# Determination 2026/004

**An authority's decision to issue two notices to fix for building work carried out without consent, a change of use and non-compliance with the Building Code**

**11 Laurence St, Manly, Auckland**

**Figure 8: Photo showing the first-floor wall removed and new timber beam/lintel in place (taken 15 December 2020).**

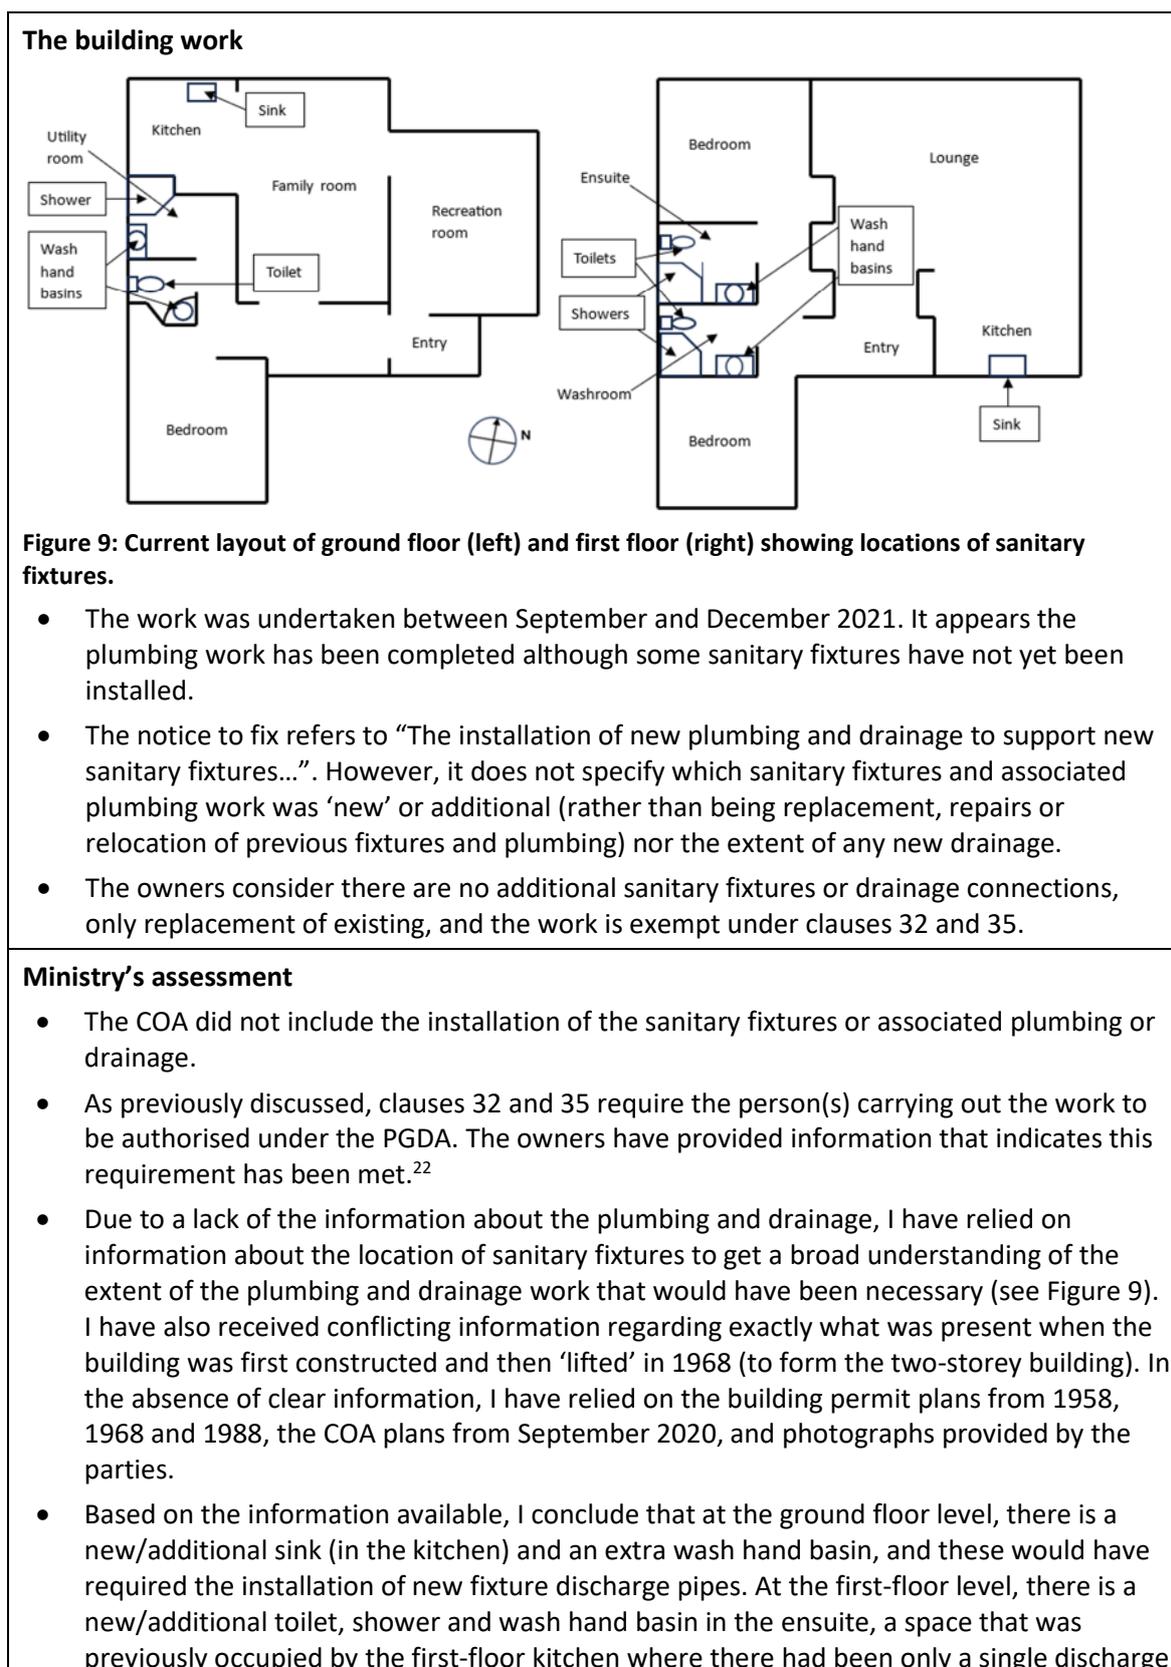
- It appears that it was only at the first floor level of the north elevation that the wall was deconstructed, though this is not clear from the wording in the notice to fix. The authority's photographs (dated 15 December 2020) show the entire first floor external wall construction, including any previous joinery, had been removed and a timber beam(s) / lintel(s) had been installed (see Figure 8). Subsequent photographs (from 21 December 2020) show the external wall reconstructed and some door and window joinery installed.
- The owners state that work was required to replace exterior windows and doors, under clause 8 of Schedule 1. They also consider it was "...not a substantial contribution to the building's structural behaviour or fire properties and therefore exemption 1 applies". The owner also states it was covered by the COA.

- It is not clear why the authority included this item in the notice to fix; the COA included the replacement of the first-floor external wall, which remedied any contravention of section 40.
- Nonetheless, I have also considered the owners' claim that the building work was exempt from requiring a building consent under clauses 1 and 8. Regarding clause 8, I note that the notice to fix concerned the removal of the external wall rather than replacement of joinery.
  - **Clause 1.** The north elevation external wall and new beam(s) / lintel(s) are integral to the structural performance of the building including supporting part of the roof

<p>structure. As such, subclause (3)(b) applies and the work was not exempt under this clause.</p>
<p><b>Ministry's conclusion</b></p> <p>The work to remove and reconstruct the first-floor north elevation wall was covered by the COA, and the authority did not detail in the notice what other work the owners were alleged to have undertaken in contravention of section 40.</p>
<p><b>Item 7 - Notice to Fix NOT21764538 (dated 27 March 2025)</b></p> <p><b>Section 40 contravention:</b> The installation of new drainage and pipework to direct storm water to the road (no connection to Council assets at time of inspection).</p>
<p><b>The building work</b></p> <ul style="list-style-type: none"> <li>• The building work includes the installation of below ground surface water drainage which is capped off inside the property. The drain is shown located to the west side of the dwelling, before crossing in a southeast direction under a 'parking' area, connecting to another drain from the southeast corner of the building, and then a single drain heads in a southerly direction terminating close to the road boundary.<sup>20</sup></li> <li>• It is not clear how the surface water collected and concentrated by the roof was disposed of before the new drain was installed, and therefore whether any of the work was existing. However, 'street view' images<sup>21</sup> indicate the previous system is likely to have relied on collecting and storing water in a large concrete tank(s) located on the property.</li> <li>• The owner considers stormwater drainage and pipework was "repair and replacement of existing" under clauses 32(1)(2) and 34(1).</li> </ul>
